March 7, 2019

**Honorable Minister Margret Miller
Environmental Assessment Branch,
Nova Scotia Environment
P.O. Box 442, Halifax, Nova Scotia
B3J 2P8**

**RE: Northern Pulp Nova Scotia - Environmental Assessment Registration Document-
Replacement Effluent Treatment Facility**

Figure 1: Observed deformations of installed HDPE pipelines (Motahari & Abolmaali, 2010)

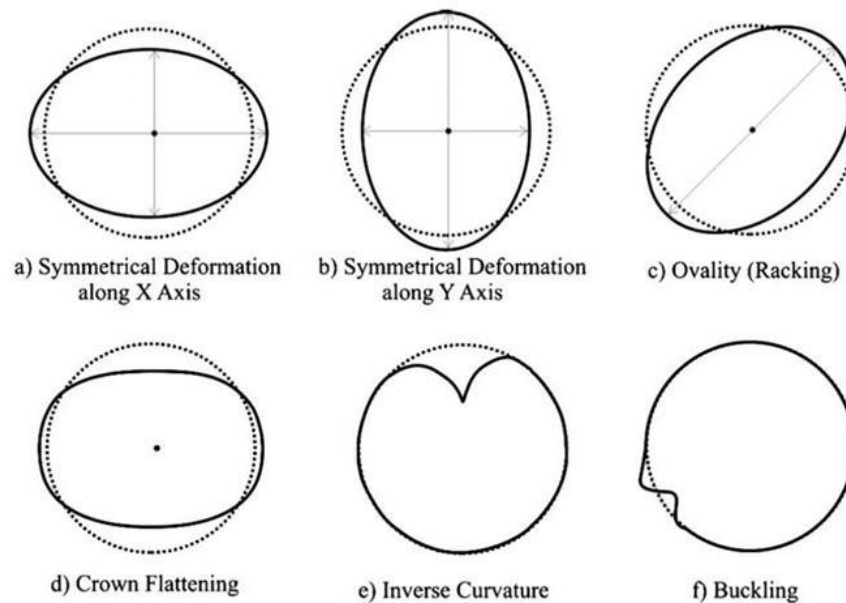
The pipeline location proposed by Northern Pulp presents various challenges that must be addressed to ensure the structural integrity of the pipe. As previously stated, the bottom has been observed by fishers to consist of soft sand and mud bottom with small pockets of hard bottom. With no geotechnical investigation carried out by any of Northern Pulps consultants it is unknown how deep the soft bottom continues. This raises the concern of non-uniform settlement of the soil that will be supporting the pipe. Due to the pipe being placed in a pre-dug trench during the construction phase it is likely that the pipe will experience increased installation deflections due to the trench quickly being filled in with sand due to wave and tidal action, thus creating discrepancies between design pipe elevations and as built pipe elevations. The pipe is also likely to experience increased in-service deflections over time due to the pockets of hard bottom creating a point of solid support while large portions of soft bottom allow for settlement and pipe sag. These deflections will induce increased compressive and tensile bending stresses within the pipe wall resulting in bending strains. The design code aims to limit these strains and the geometric stability of the pipe by setting ring deflection limits of 7.5%. As deflections increase beyond this point geometric stability is eventually lost and the crown of the pipe will begin to flatten and eventually

reverse leading to reverse curvature collapse of the pipe Figure 1 shows observed pipe deformation patterns that lead to failure due to increased pipe deflections (Plastic Pipe Institute, 2014).

Figure 1 is from a study published in the Journal of Transportation Engineers of the American Society of Civil Engineers (ASCE). The study included structural monitoring with video and laser surveillance of over 15,000ft (96 pipelines) of buried HDPE pipe across the USA. It was concluded that the majority of pipelines had actual deformations in excess of design code limits (Motahari & Abolmaali, 2010). This study gives great insight into the possible repercussions of not accurately modeling induced strains in buried HDPE pipes.

Due to the lack of detail presented concerning site-specific data of various elements of the project, the minister must request an environmental assessment report. The report should include a geotechnical investigation, hydrographic survey and further investigations detailing ice presence. Pipe deformation issues should be addressed and a study must be conducted to ensure that direct ice impact will not occur. A detailed tidal study should be carried out to ensure that the effluent will not intrude into Caribou harbour severely effecting the marine ecosystem.
